<b>Title - Sujet</b> Kitsilano CCG SAR Workshop Reconstr Kitsilano CCG SAR Workshop Reconstruction	
<b>Solicitation No. - N° de l'invitation</b> F521A-210639/A	<b>Amendment No. - N° modif.</b> 002
<b>Client Reference No. - N° de référence du client</b> F521A-210639	<b>Date</b> 2021-10-25
<b>GETS Reference No. - N° de référence de SEAG</b> PW-SPWY-047-9052	
<b>File No. - N° de dossier</b> PWY-1-44096 (047)	<b>CCC No./N° CCC - FMS No./N° VME</b>
<b>Solicitation Closes - L'invitation prend fin</b> <b>at - à 02:00 PM</b> Pacific Daylight Saving Time PDT <b>on - le 2021-11-02</b> Heure Avancée du Pacifique HAP	
<b>F.O.B. - F.A.B.</b> <b>Plant-Usine:</b> <input type="checkbox"/> <b>Destination:</b> <input checked="" type="checkbox"/> <b>Other-Autre:</b> <input type="checkbox"/>	
<b>Address Enquiries to: - Adresser toutes questions à:</b> Kyle (PWY), Davis	<b>Buyer Id - Id de l'acheteur</b> pwy047
<b>Telephone No. - N° de téléphone</b> (250) 869-6395 ( )	<b>FAX No. - N° de FAX</b> ( ) -

## **Kitsilano CCG SAR – Workshop Reconstruction Addendum #1**

**Kitsilano Coast Guard Base Replacement (DWG# 705149-G4 to G6).**

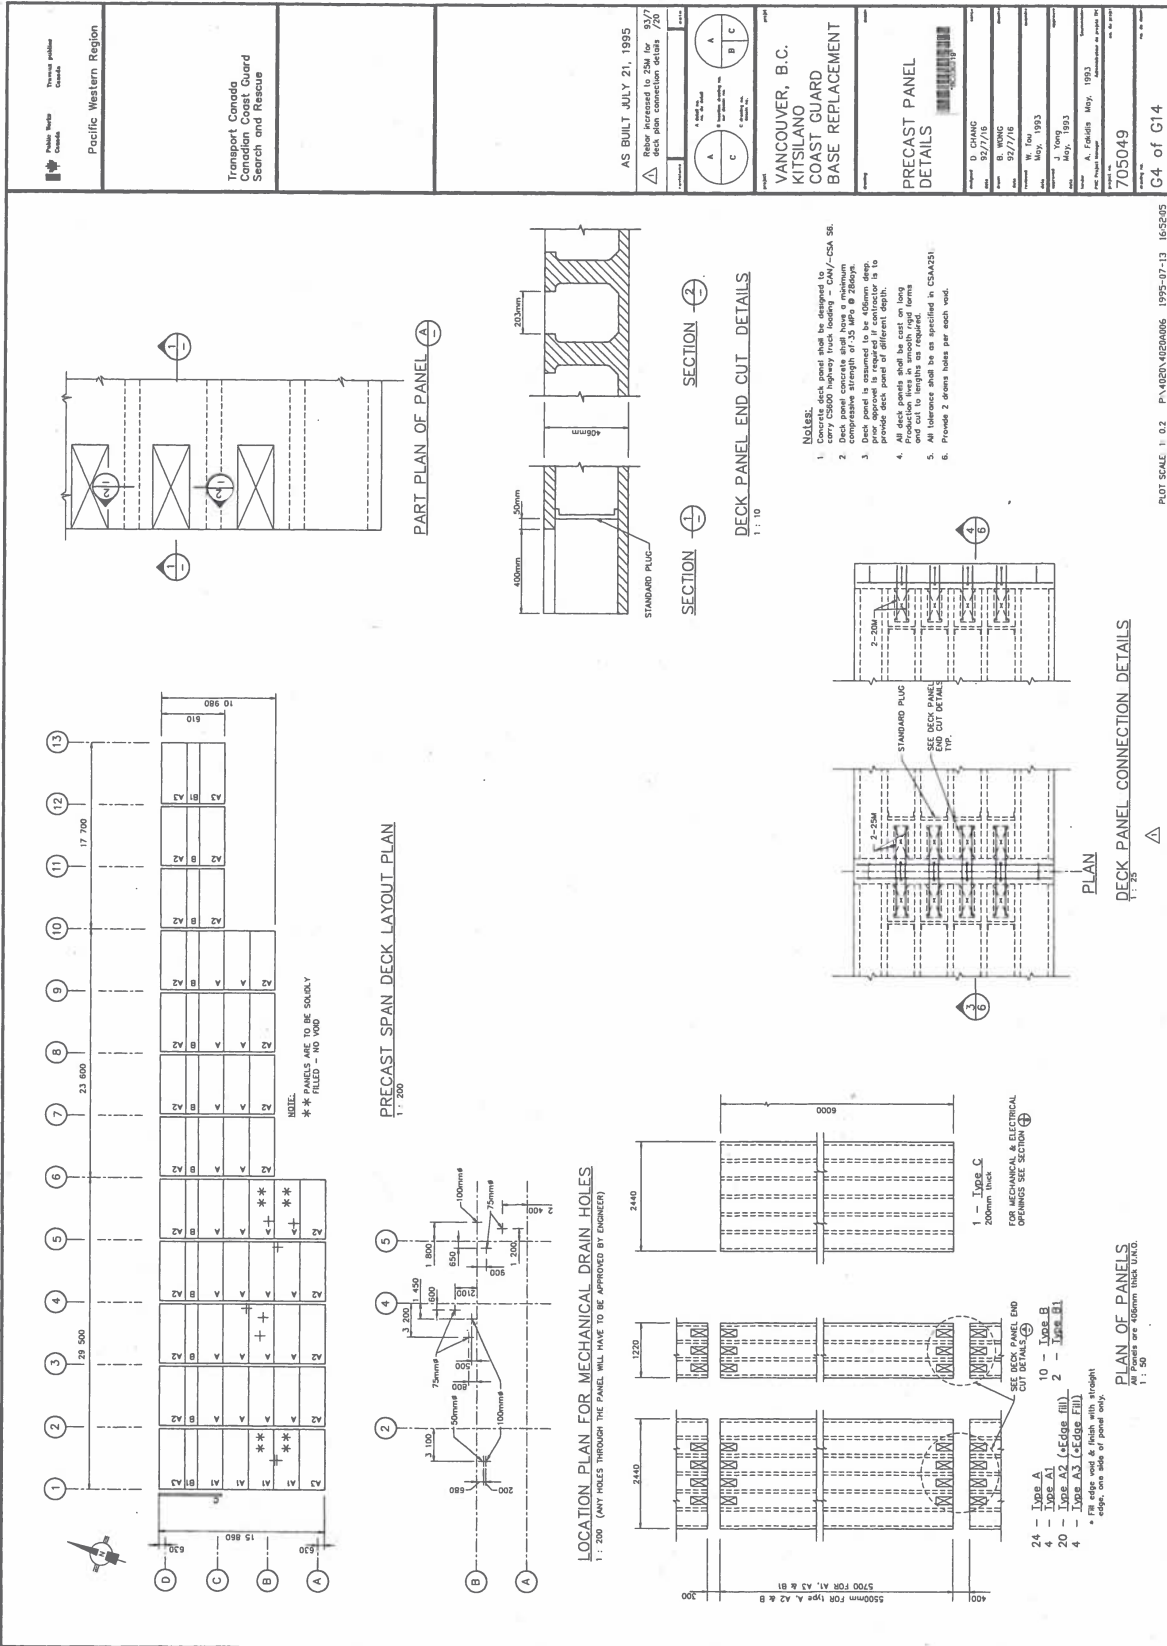
#### **1. What is the thickness of the concrete slab at the Wharf**

The concrete slab at the wharf consists of 406mm thick precast panels with a 100mm thick cast-in-place topping slab. See Amendment #1 below.

**Kitsilano CCG SAR Workshop Reconstruction - Wharf Access.**

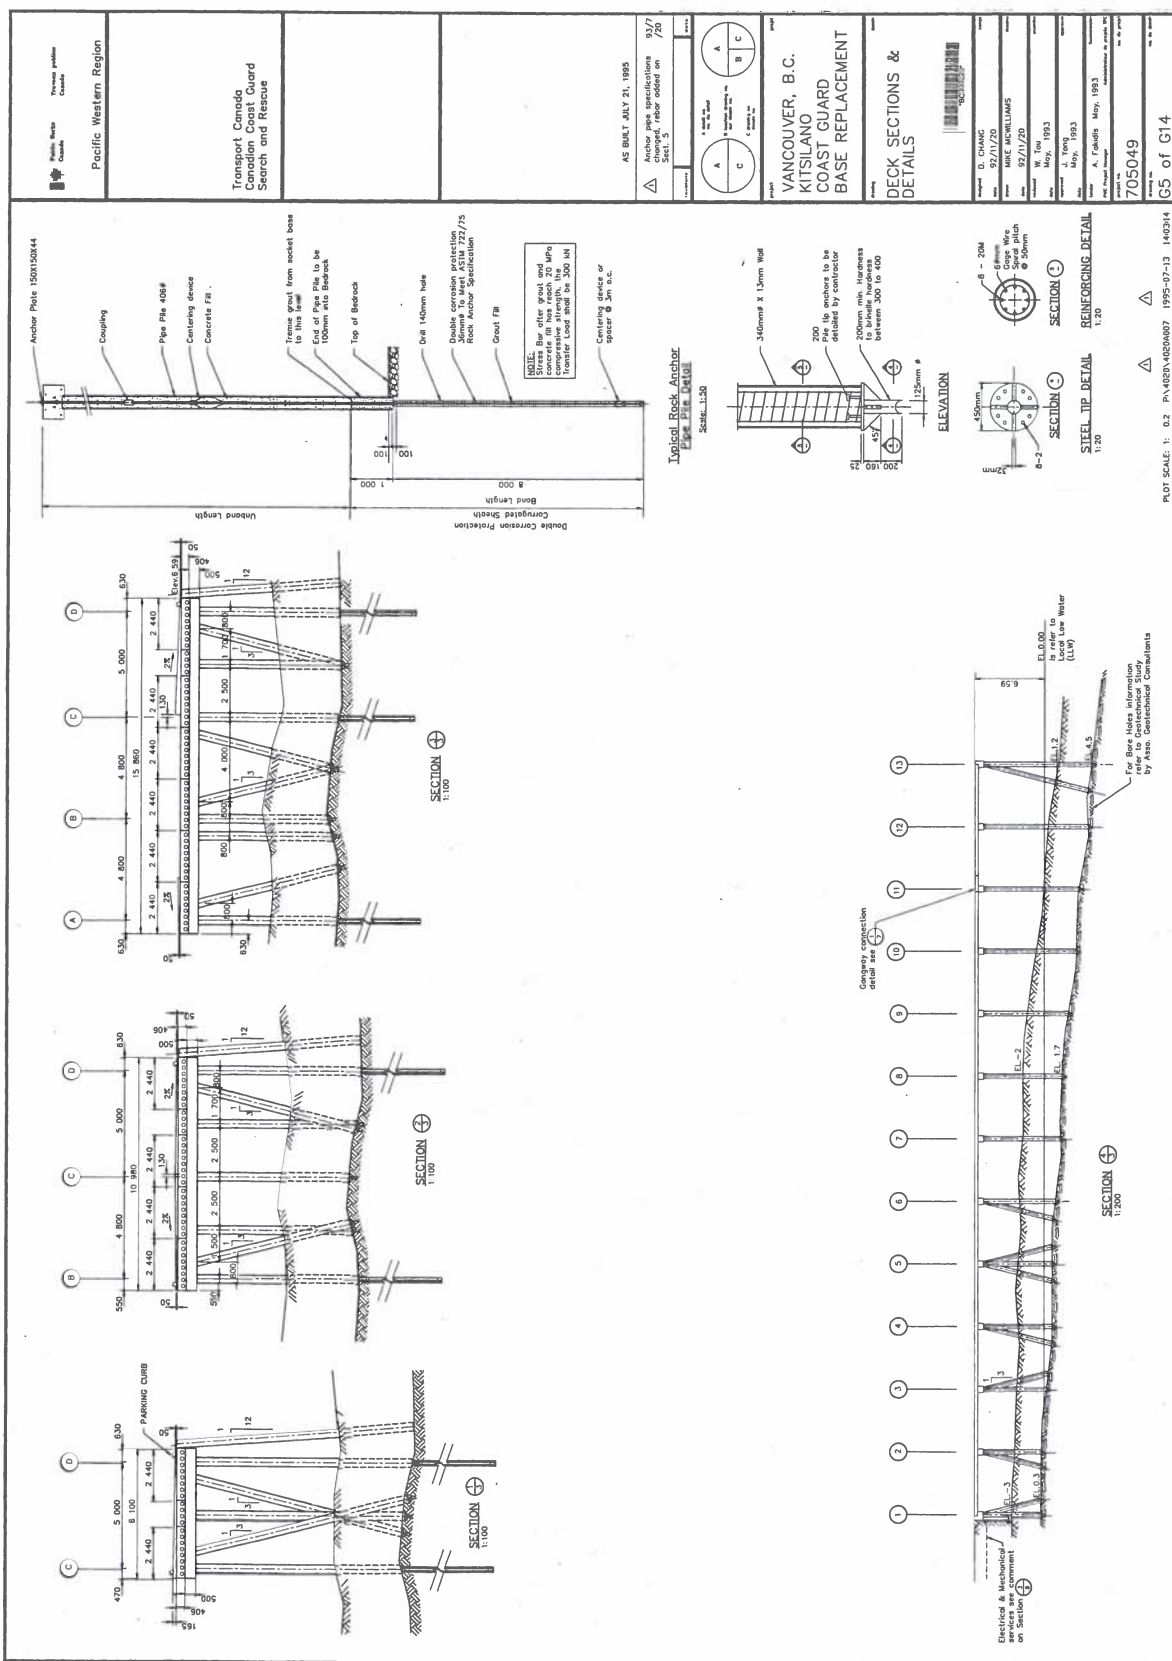
#### **2. Bins and storage location ?**

The East side of the wharf North of the existing station building can be utilized for staging and storage during construction. The West side of the wharf is for emergency access and must be kept clear at all times. Parking on the wharf will not be permitted. See Amendment #2 below.

**Kitsilano CCG SAR Workshop Reconstruction – Square D Panel (2 Photos).**

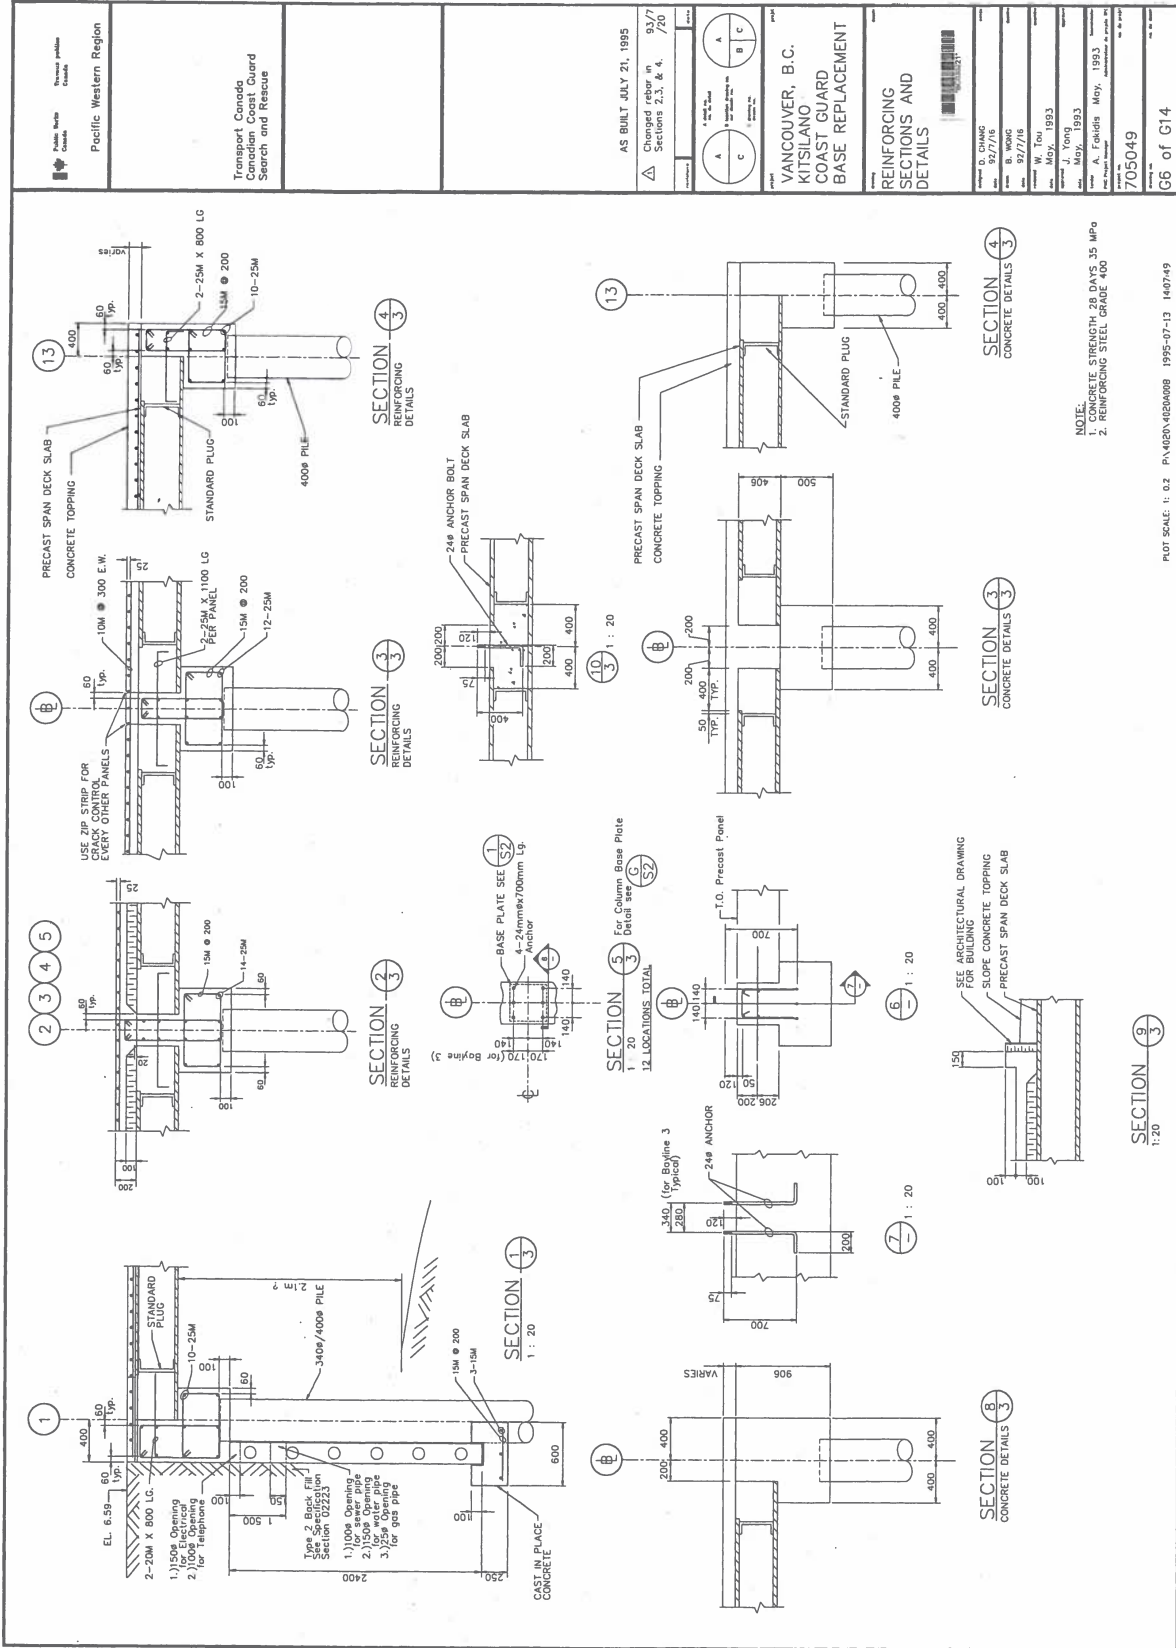
- 23. Do you have any photos from the site for electrical works? We will need to know for tying into the existing Main Panel - 6A**

See Attachment #4.
